## Wiltshire Council Planning Consultation Response

### URBAN DESIGN

**Application No:** PL/2026/02443

**Proposal:** *Erection of 47 dwellings with associated access, internal roads, parking, public open space, landscaping, drainage and associated infrastructure.*

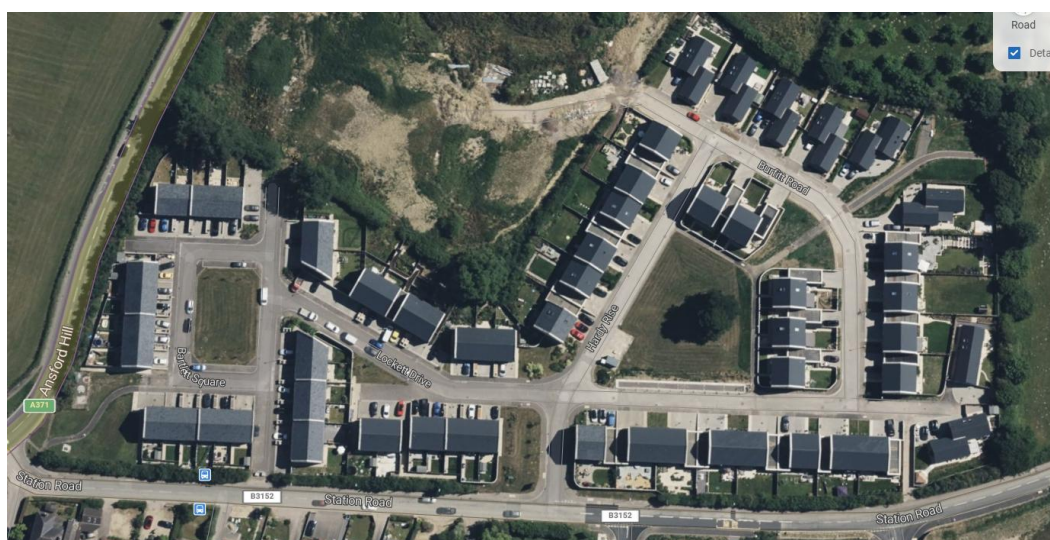
- 5) The move away from underground attenuation tanks is also welcomed. This represents a positive shift towards more visible and multifunctional drainage solutions.

There still remains an opportunity to further integrate sustainable drainage features within the streets themselves. Both BfHL and the WDG (Sections 6.3 and 6.5) expect sustainable drainage to be integrated into streets and open spaces as multifunctional green and blue infrastructure using a combination of wetlands, rain gardens, small ponds, and permeable surfaces, rather than appearing as isolated or engineered features. At present, the SUDs could make a more meaningful contribution to the street character.
